**CORRECTIONS FOR EROSION AND SEDIMENT POLLUTION CONTROL PROGRAM MANUAL
ID 386-2134-001, March 2012**

| Page(s) | Correction |
|---------|--|
| 46 | Revise Figure 3.11 as follows: |

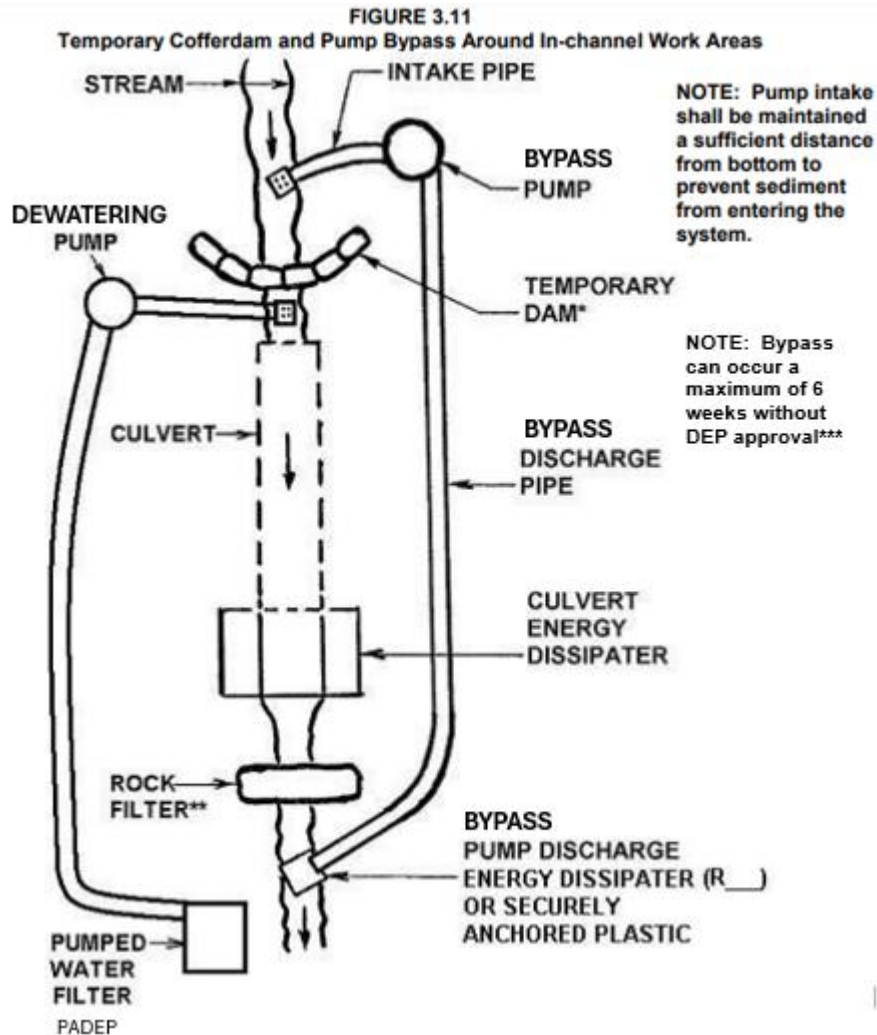
- * Sandbags (Standard Construction Detail #3-15), Jersey barriers (Figure 3.13) or other non-erosive material, no earth fill. Do not excavate a sump for the pump intake.
- ** See Standard Construction Detail #4-14. For low gradient channels, the rock filter may be replaced by an impervious cofferdam to prevent backflow into the work area.
- *** Based on a joint water quality evaluation study conducted by DEP’s Bureau of Clean Water and PennDOT’s Bureau of Design and Delivery from 2020 to 2024. DEP must approve durations greater than 6 weeks.
